**Re: Chiquita Canyon, LLC – Response to EPA’s Further Comments on the
West Toe Buttress Work Plan, Docket No. RCRA 7003-09-2024-0001 and
CERCLA 106-09-2024-05**

**Chiquita Canyon, LLC – August 14, 2026 Response to EPA Comments on the West Toe
Buttress Work Plan**

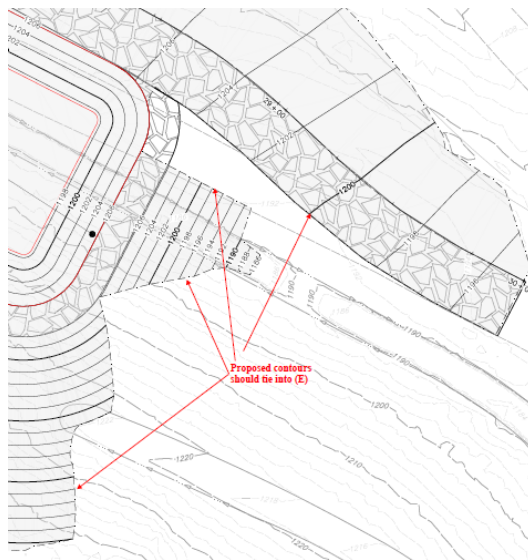
9. Regarding the Lower Buttress and Backcut Plan, Drawing CS104, in Appendix F:

- a. For the feature at the Grids E/D 4/5, the slope exceeds 2:1 (H:V). Again, CCL should supplement the design with a dynamic analysis to determine the FoS.*

- b. For the feature at the Grids E/D 4/5, CCL should justify the setbacks to PL per the Los Angeles County Building Code (2023) J108.1-J108.4.*

- c. Identify the major contour information for the portion of the features at Grids G/F 3/2.*

Please refer to CCL's response in Section I.1.a, above.

Please refer to CCL's response in Section I.2, above.

CCL has included this information in the updated drawing set (see Appendix F, Sheet C104).
